**TECHNICAL BULLETIN**  
**Bell Helicopter** **TEXTRON**

No. 205B-06-29

**MODEL AFFECTED:** 205B

**SUBJECT:** VERTICAL FIN COVER HINGE PIN IMPROVED  
INSTALLATION

**Figure 1**  
New Hinge Pin Installation

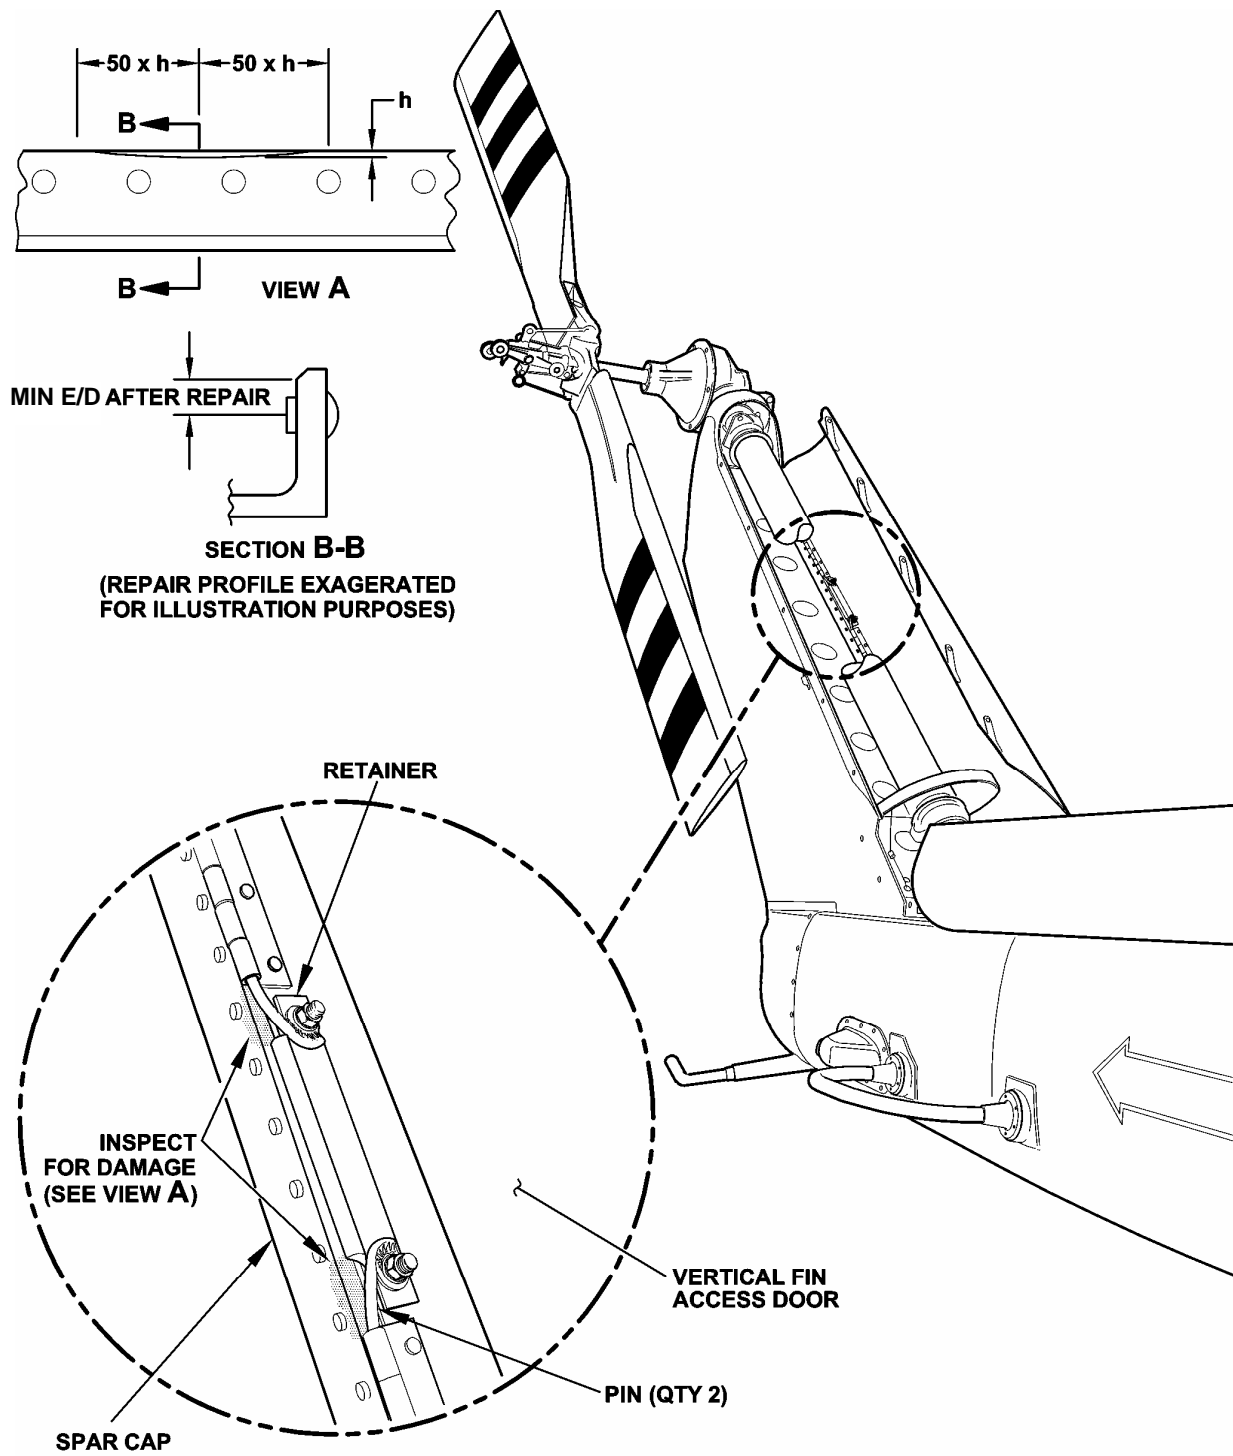
Bell Helicopter has designed a new installation for the vertical fin cover to prevent chaffing damage to the left hand spar cap caused by improperly bent hinge pins. This technical bulletin allows retrofit of the installation on earlier aircraft.

5. Inspect spar cap as indicated in Figure 1, View A, for any chafing damage caused by improperly installed hinge pins.
  - a. Chafing damage of 0.040 inch-deep or less (up to the full width of the flange) may be blended to a length-to-depth ratio of 50:1 (in each direction from the deepest point) and refinished, provided the distance between the center of the nearest rivet and the repaired area is at least 1.5 time the rivet diameter (min E/D). Remove minimum amount of material and polish repair area using 400-grit sandpaper. Removal of the hinge from the fin may be required.

- c. Report any damage in excess of 0.040 inch-deep to Product Support Engineering.

- b. Perform a Fluorescent Penetrant Inspection per Standard Practices Manual, followed by application of chemical film to the repaired area per Structural Repair Manual Section 3-2-14. Refinish area in accordance with Standard Practices Manual.

6. Reinstall door by inserting Pins P/N 209-031-816-119. Attach pins to door using existing screws, 209-031-816-123 Retainer and MS21042L3 Nuts, as shown on Figure 1. Close door.
7. Make an entry in helicopter historical records indicating compliance with this technical bulletin.
8. Make helicopter safe for flight.
